Submit an updated drainage report meeting current criteria

FINAL DRAINAGE REPORT
for
FALCON ACRES SUBDIVISION

Add PCD File No. SF223

FIGURE 3-2. ESTIMATE OF AVERAGE FLOW VELOCITY FOR USE WITH THE RATIONAL FORMULA.

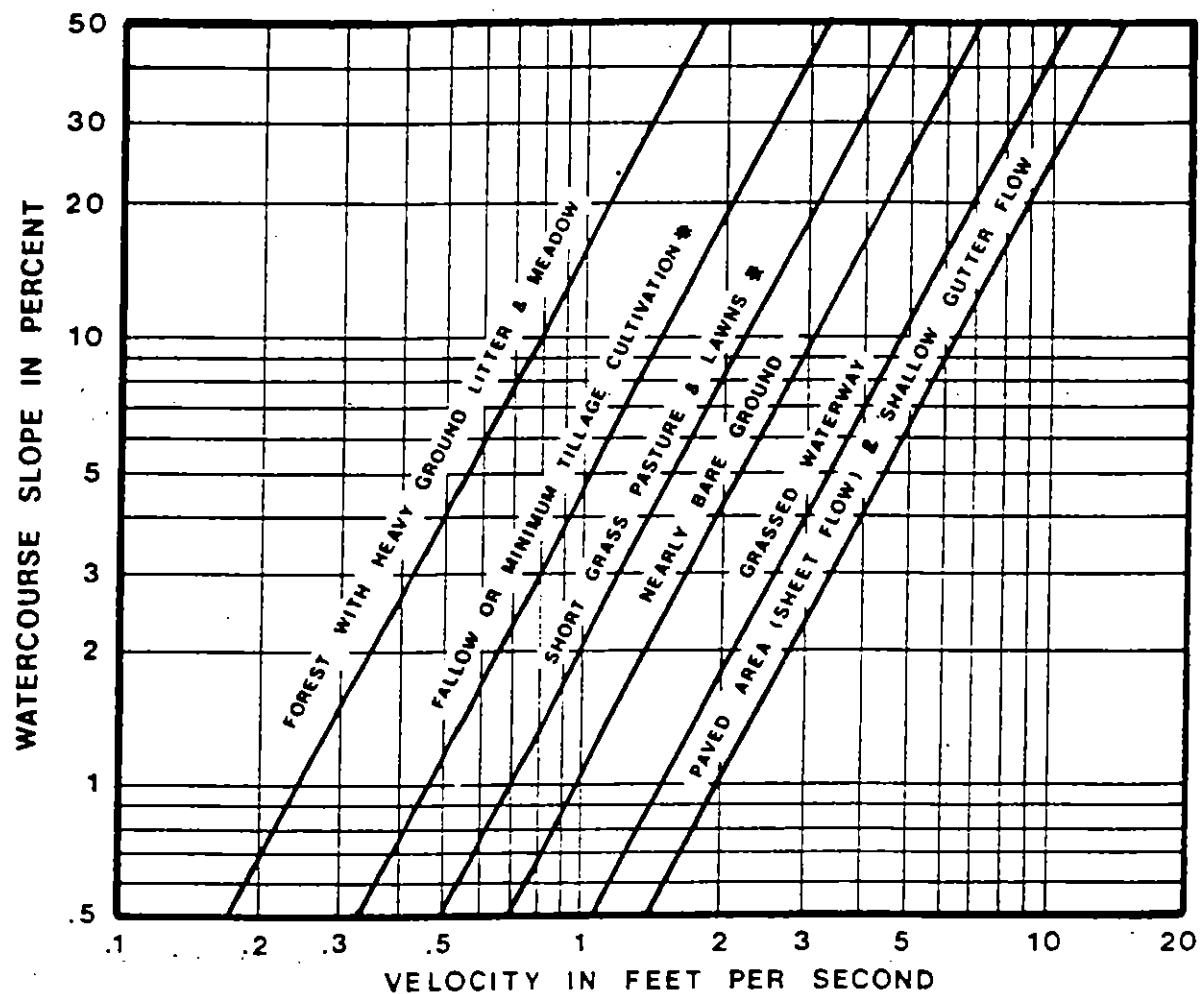
Replace with current
criteria

FIGURE 3-2. ESTIMATE OF AVERAGE FLOW VELOCITY FOR
USE WITH THE RATIONAL FORMULA.

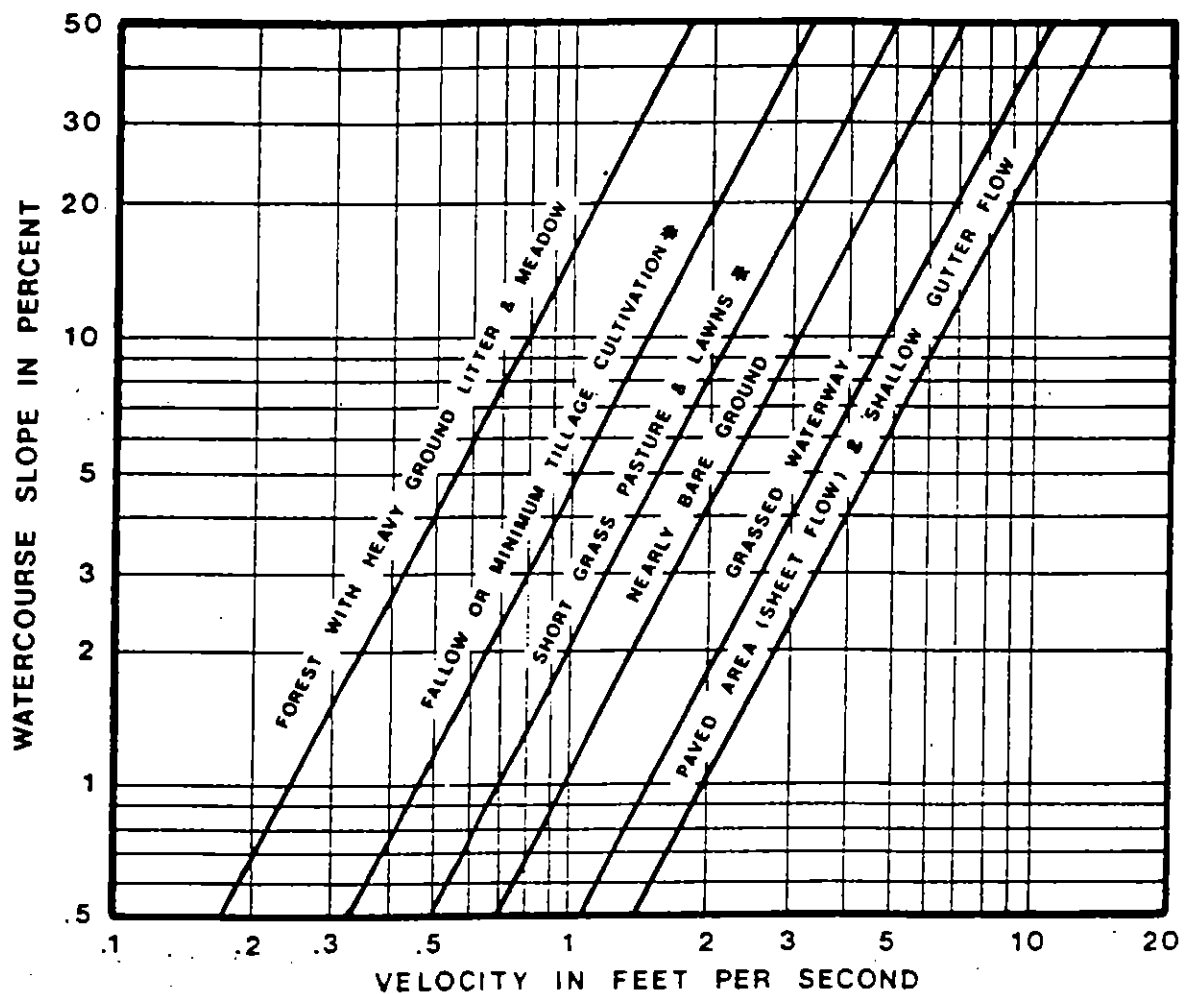
Replace with current
criteria

FIGURE 5-7. RIPRAP EROSION PROTECTION AT CIRCULAR CONDUIT OUTLET.

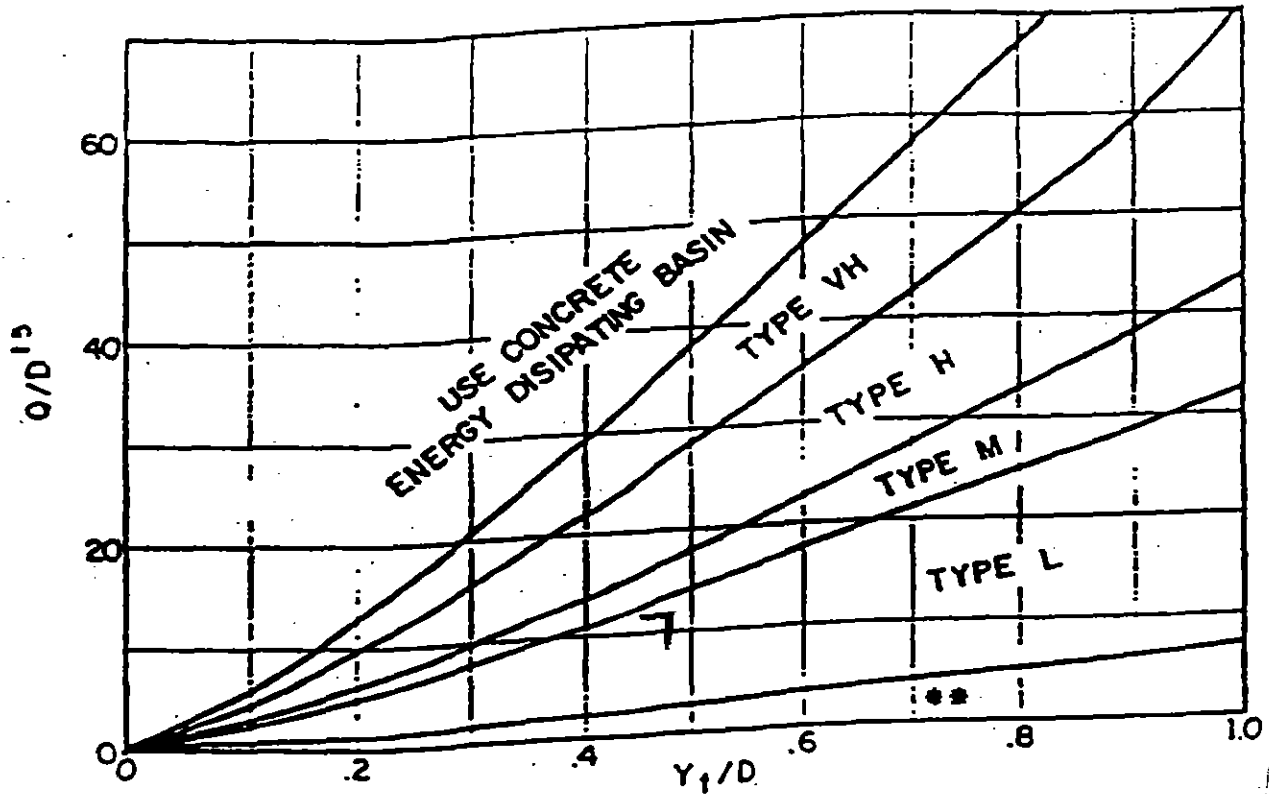
Replace with current figure. typ all

DEVELOPED DRAINAGE PLAN

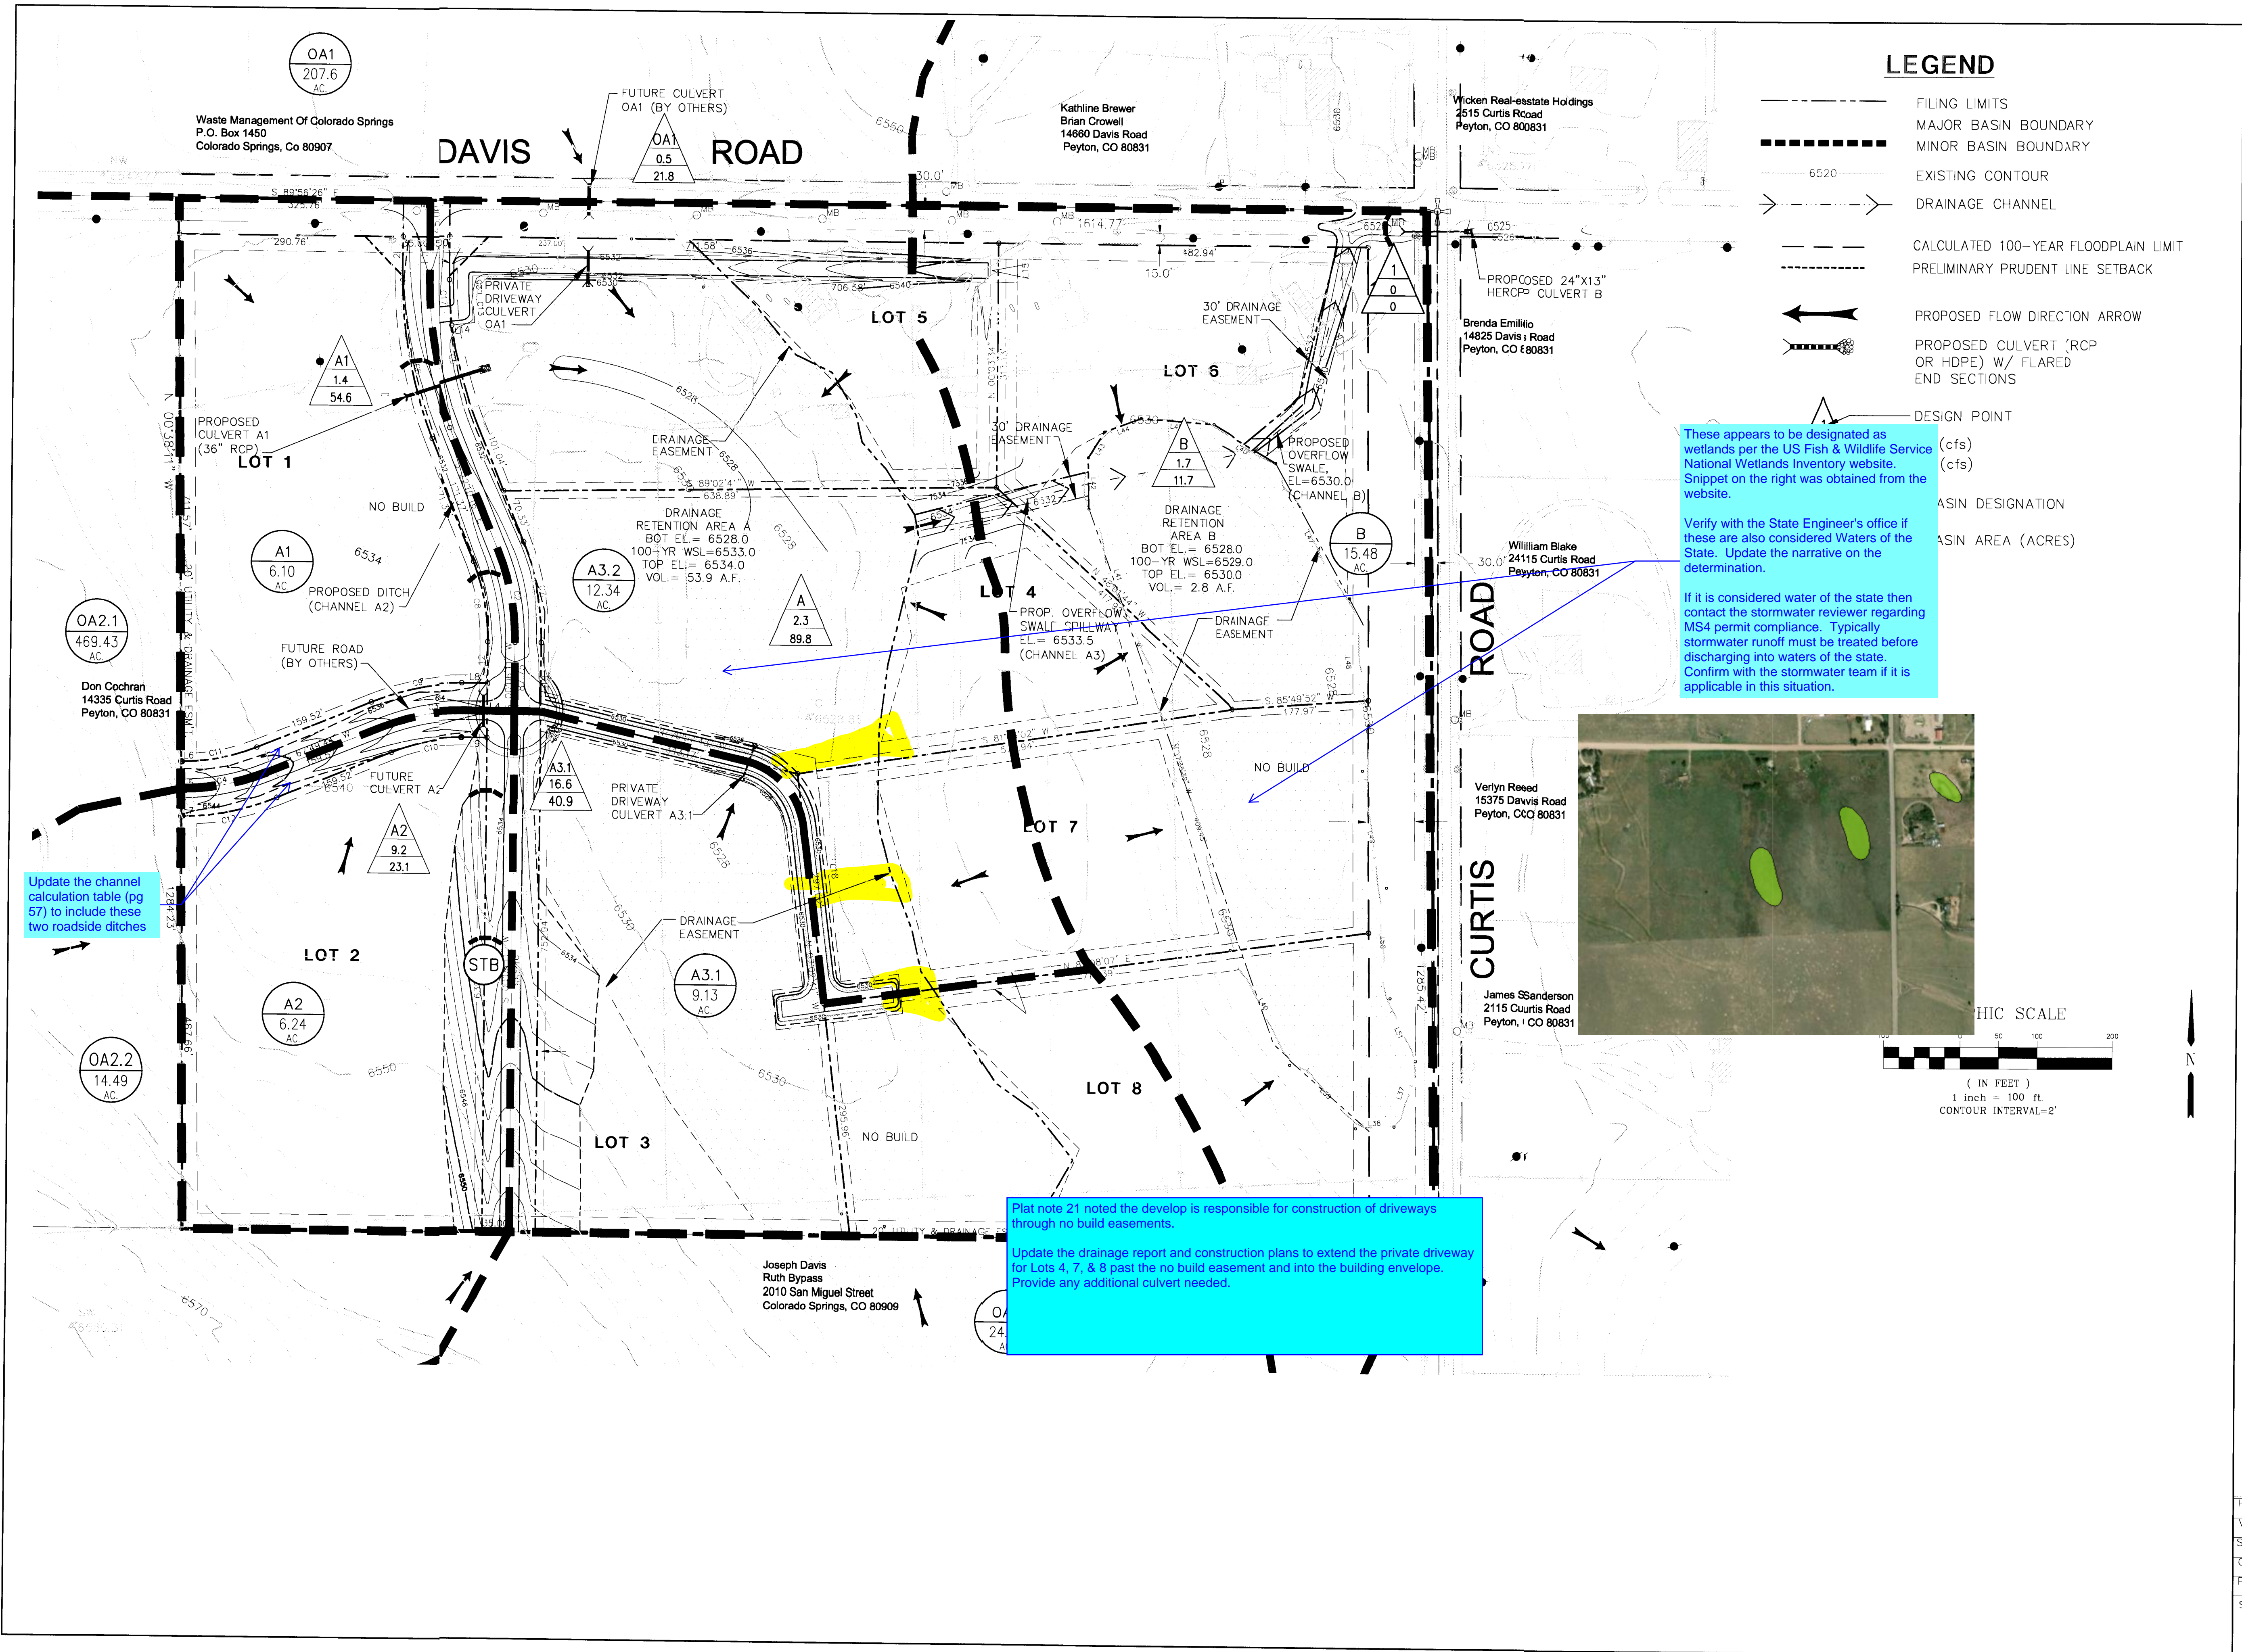
Upload a clearer drainage map. The existing contours are difficult to read. Unable to tell what elevation the drainage easement follows.
